# ANACONDA

SUBJECT: Revision of AWC-75-A  
Referring to your letter of August 27, 1979  
Phone call to Mr. Spraul of September 19, 1979

PROPOSED CHANGE  
FOR  
ANACONDA  
QUALITY ASSURANCE MANUAL  
FOR  
GENERATING STATION CABLES  
TOPICAL REPORT AWC-75

Section Number Exhibits Paragraph Number(s) Exhibit #1

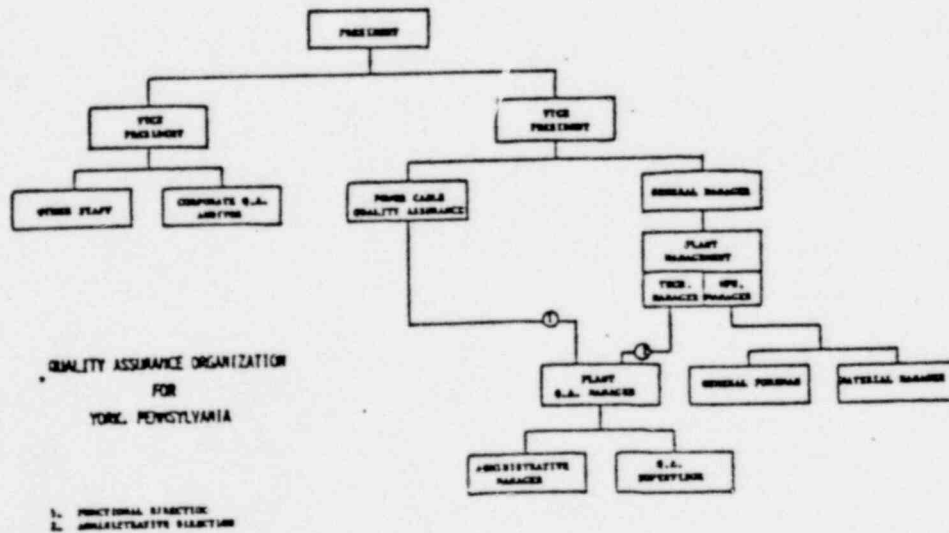
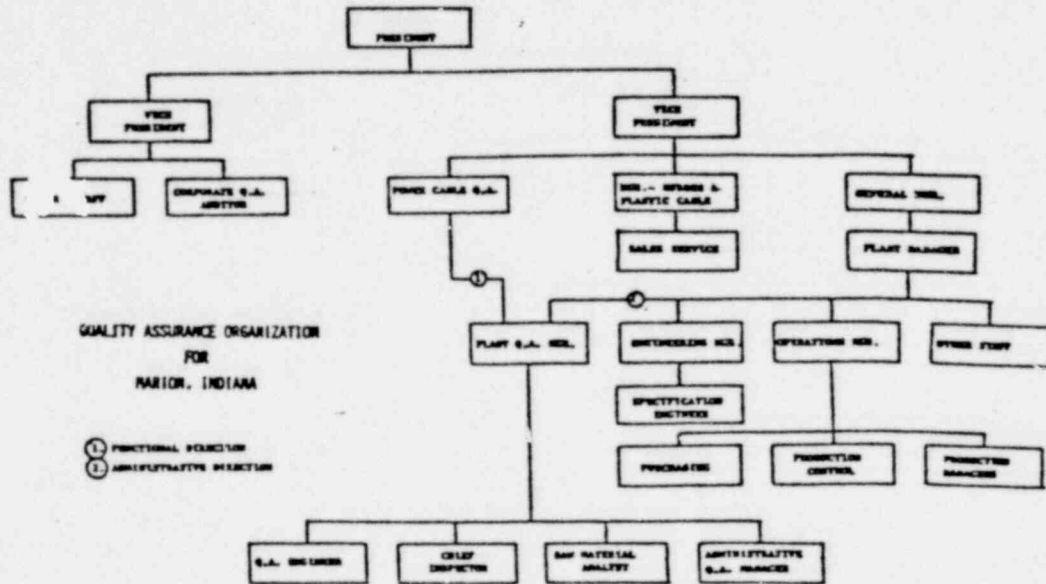
Due to various changes in titles and due to the difference in organizations at Marion and York Exhibit #1 is being changed to reflect what is in actual effect at these two (2) locations. (See proposed Exhibit #1 on page 2)
